## **ADDENDUM #4**

### **Rye City School District**

#### **Osborn Elementary School**

#### **Midland Elementary School**

**Approver**  
SEAL & SIGNATURE | DATE: 07/27/20  
PROJECT No: 9200  
DRAWING BY: Author  
CHK BY: Checker  
DWG No: A3-601

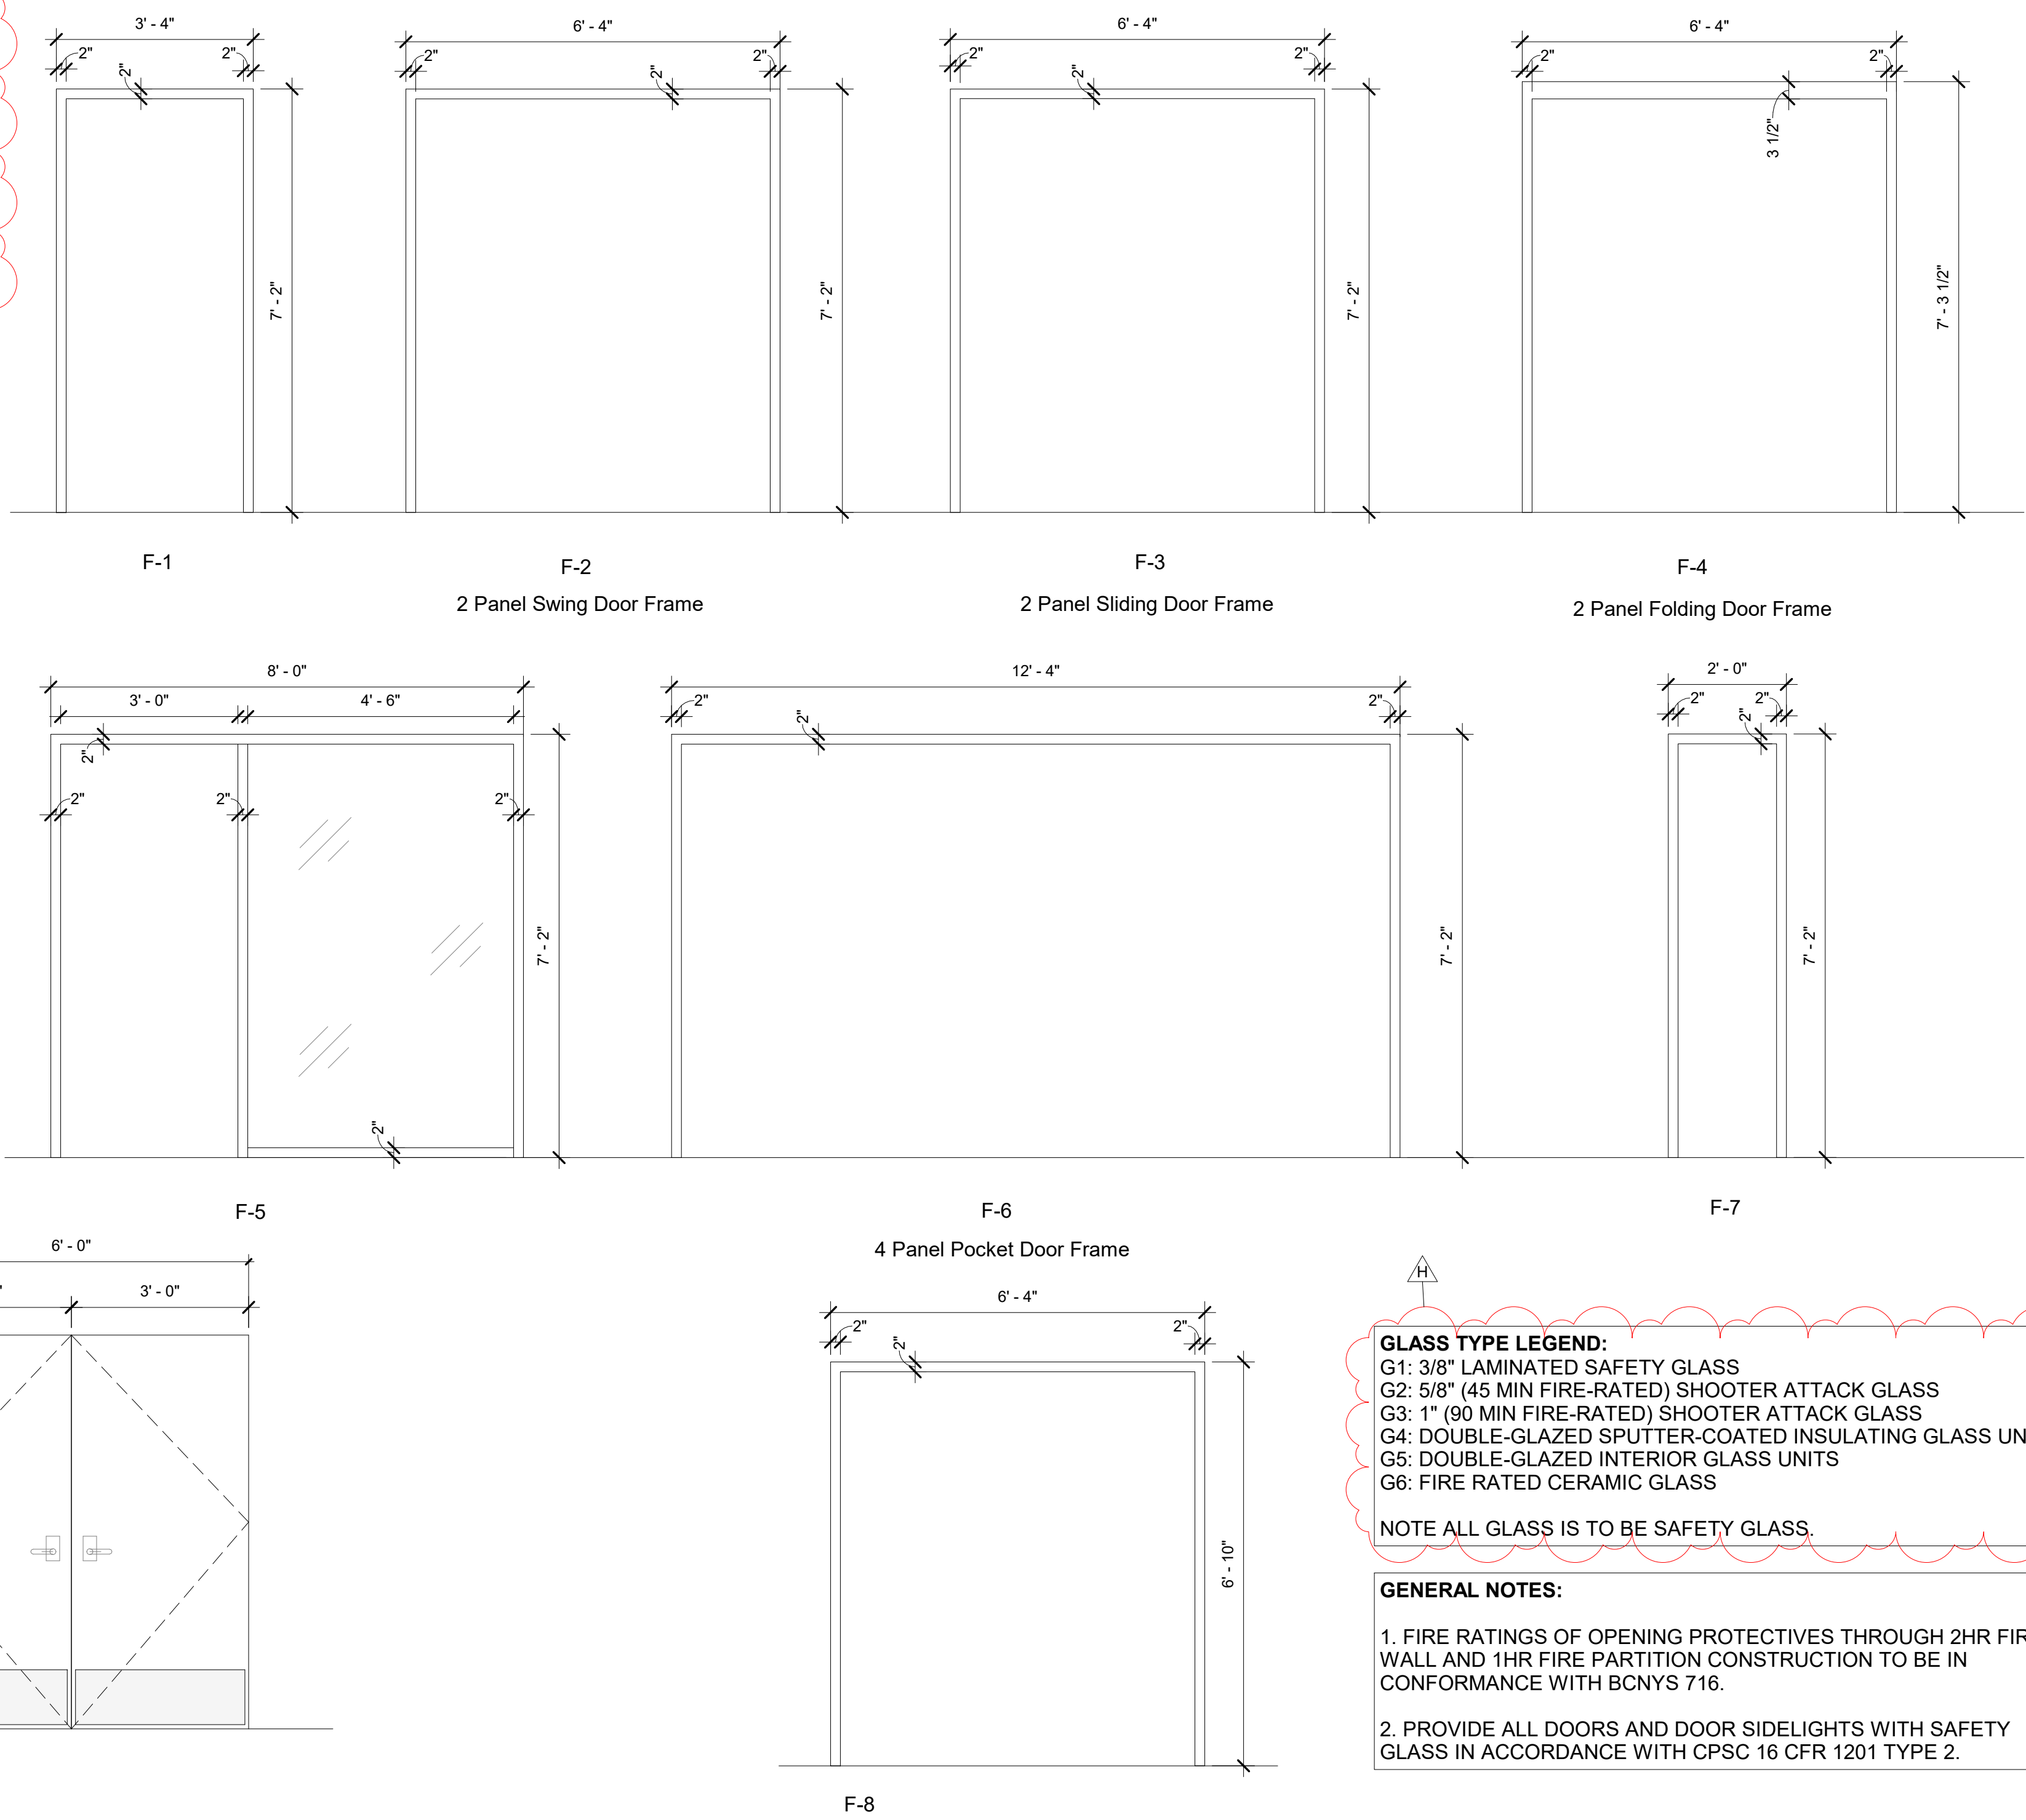
3. A3-601 – DOOR & FRAME TYPES AND SCHEDULE
  - a. Door types and dimensions adjusted to correspond to allowable glazing size for fire-rated doors. Door types D-3A and D-3B added.

- b. Hardware groups added for doors where this information was previously missing
  - c. Door material clarified for exterior doors to be aluminum/glass

**Answer:** Correct. LVT-1 is Shaw Solitude LVT; Color 48516 Fawn; 4100 adhesive. Updated finish legend provided in this addendum.
2. **Question:** The hardware sets on the door schedule do not line up with the spec documents. What door material is the intruder resistant glass doors? Please advise.

3. **Question:** Hardware sets missing from door schedule.  
**Answer:** Updated hardware specs are provided in this addendum. Updated door schedule with missing sets provided in this addendum.

**Answer:** Updated hardware specs are provided in this addendum. Door material for intruder resistant glass doors is aluminum/glass. An updated door schedule with these clarifications is provided in this addendum.

DATE: 09/11/20  
PROJECT No: 9200  
DRAWING BY: Author  
CHK BY: Checker  
DWG No: A3-602

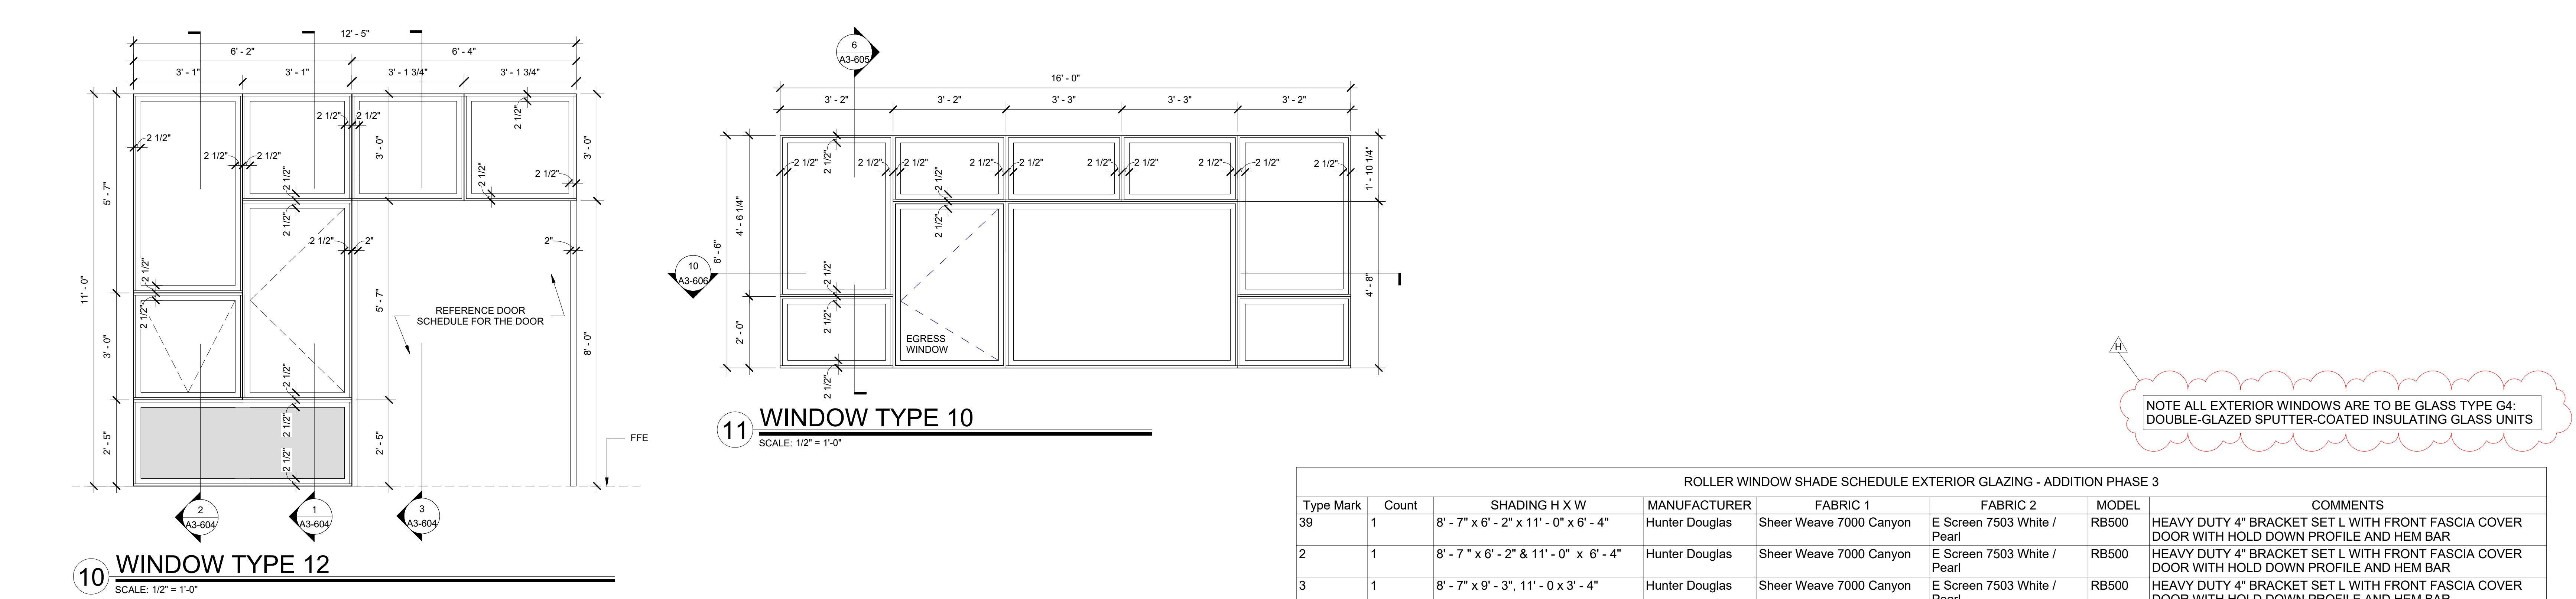
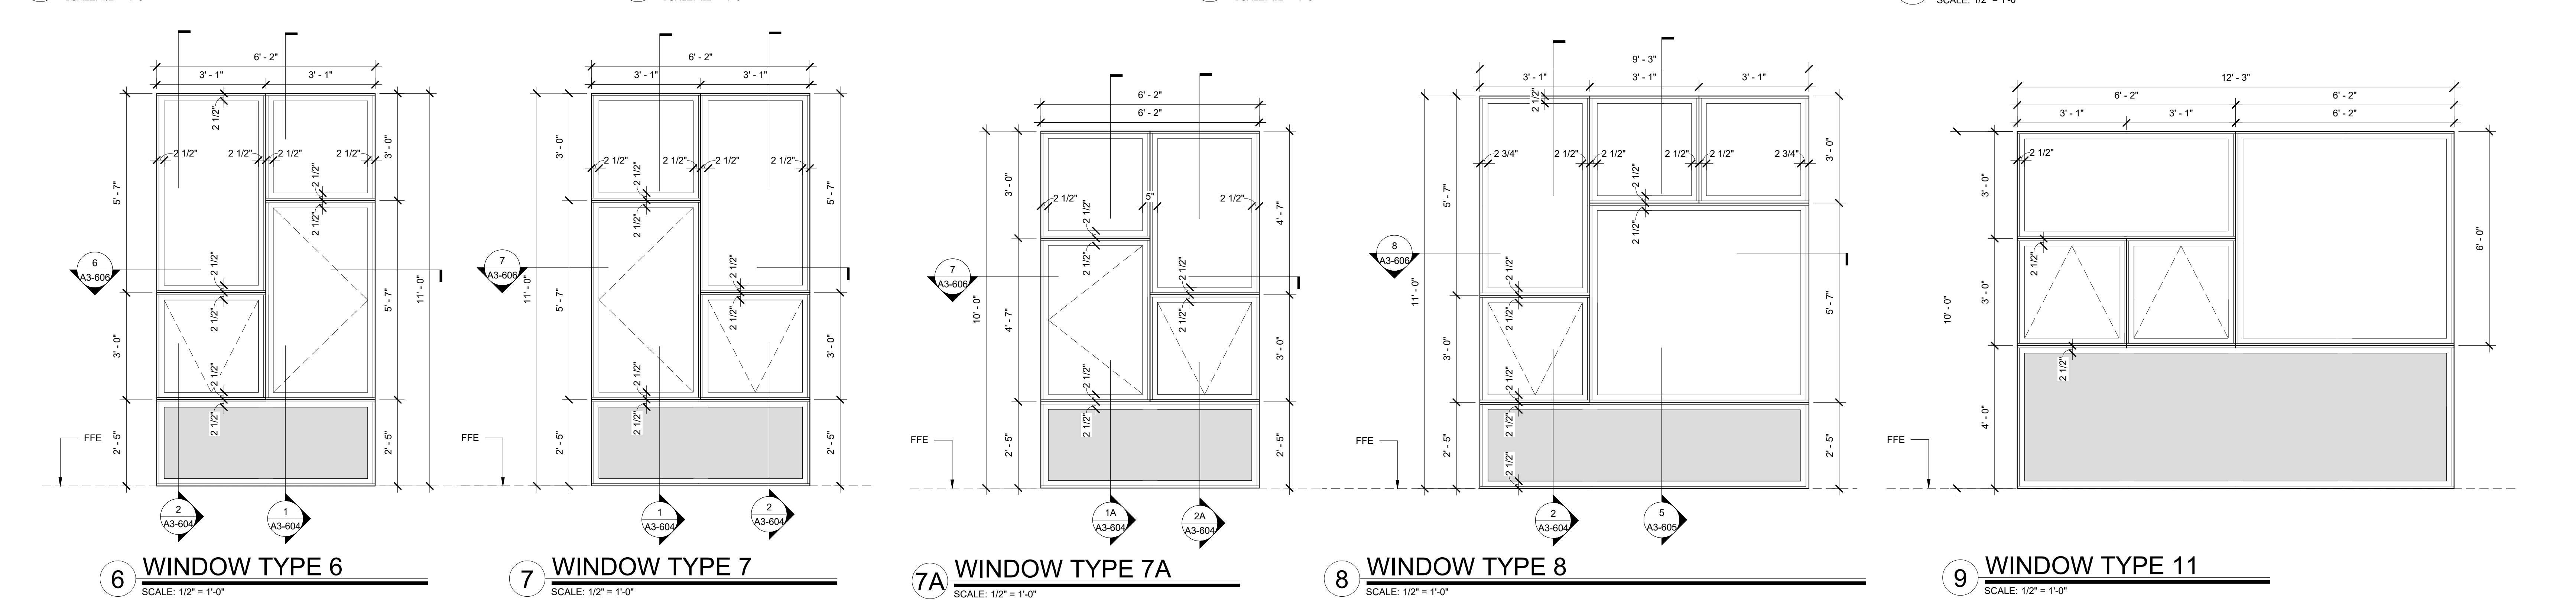
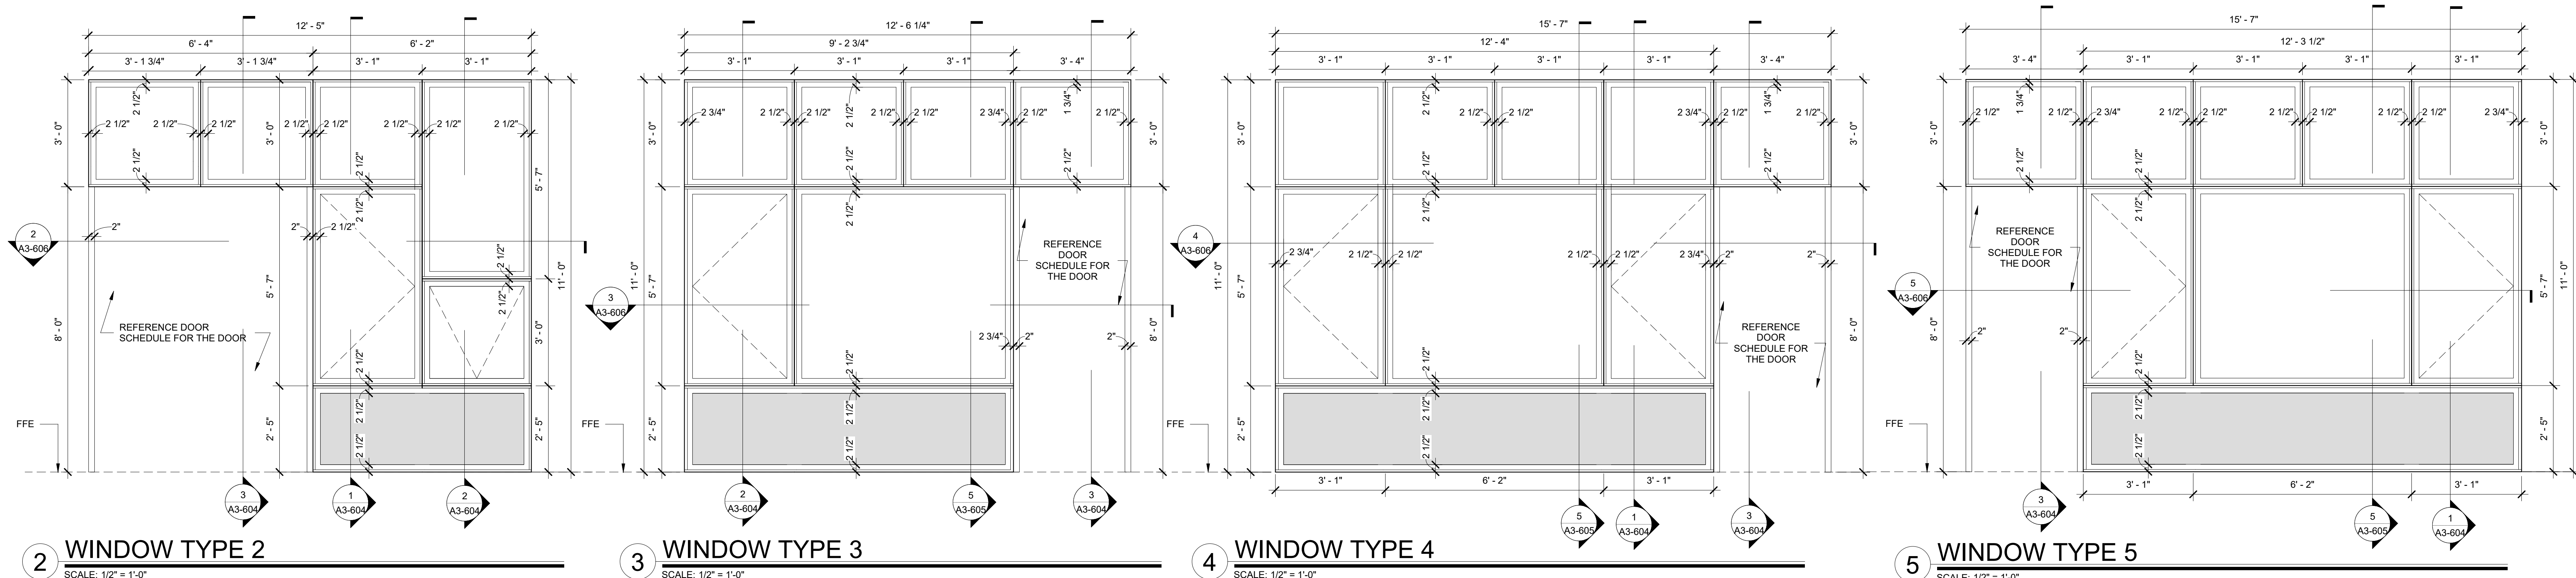
- d. Glazing Type legend added to sheet
  - e. Glazing type column added to door schedule
4. A3-602 – INTERIOR WINDOW TYPE AND SCHEDULE
  - a. Glazing type column added to interior glazing schedule

5. **Question:** Detail 2 on A3-602 (both schools). The interior window schedule shows frame mark cc-1, cc-2, cc-3, and cc-4 CRL manufacturer/487-AR 45 min. firerated. CRL product is a non-fire rated demountable partition system and not a fire resistant product associated with section 088813. Please clarify whether these interior frames are to be non-rated interior demountable partitions or interior fire rated frames per 088813.

**Answer:** These windows do not need to be fire-rated. Updated schedule provided in Addendum #4.
6. **Question:** Please provide glazing schedule on the architectural drawing associating the different glass products found in section 088000 with aluminum/HM/wood doors frames and windows.
